# FREELAND and KAUFFMAN, INC.

Subject: Caliber Collision - Commercial Preliminary Development Plan  
710 SE Blue Parkway, Lee's Summit, MO 64063

Application No: PL2021279

This letter is being sent to confirm the receipt of the City's review comments during the Analysis of the Commercial Preliminary Development Plans (PDP) for Caliber Collision at the subject address. Below are the comments received followed by the response of how they were addressed:

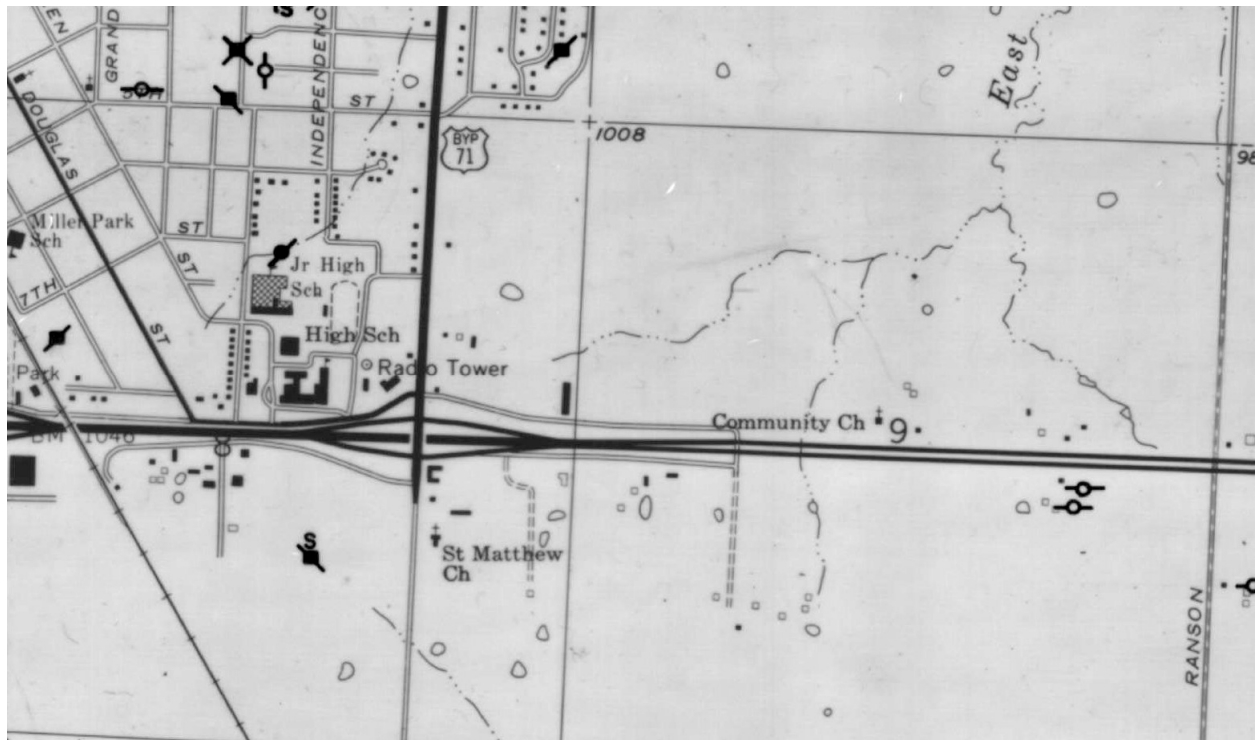
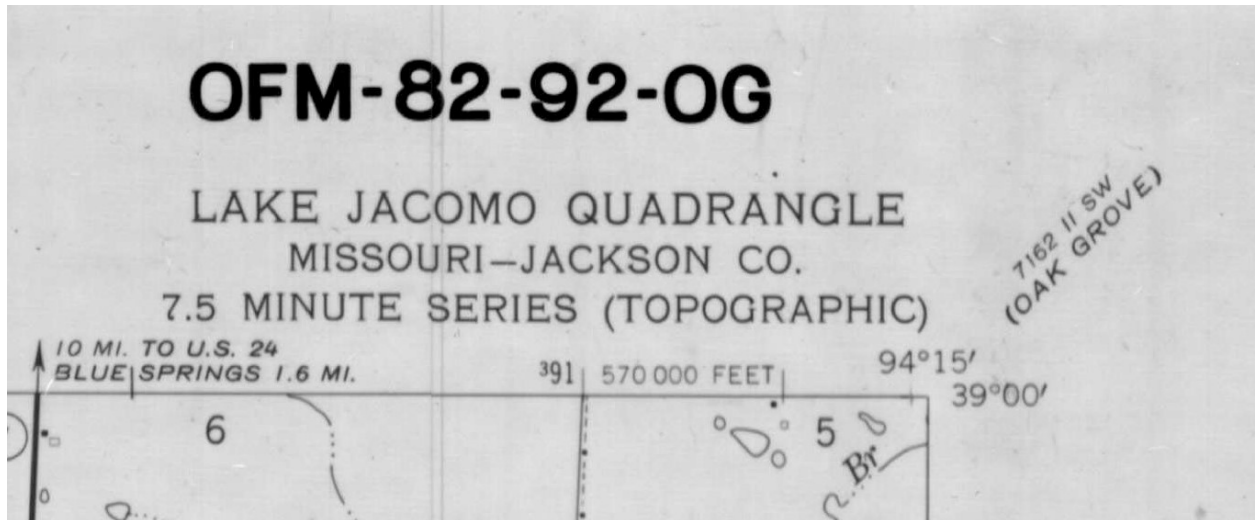
2. Oil and Gas Wells. Please state whether or not there are active, inactive, or capped wells with the area. Refer to DNR Well Database and reference the site. Please state there are no wells on the plan.

**RESPONSE:** Per the MoDNR Well Database for Oil and Gas Wells, there were not active, inactive, or capped wells located on the property. An image from the Map is shown below. Additionally, a note has been added to the Site Plan, sheet #8, that states there are no oil or gas wells located on the property.
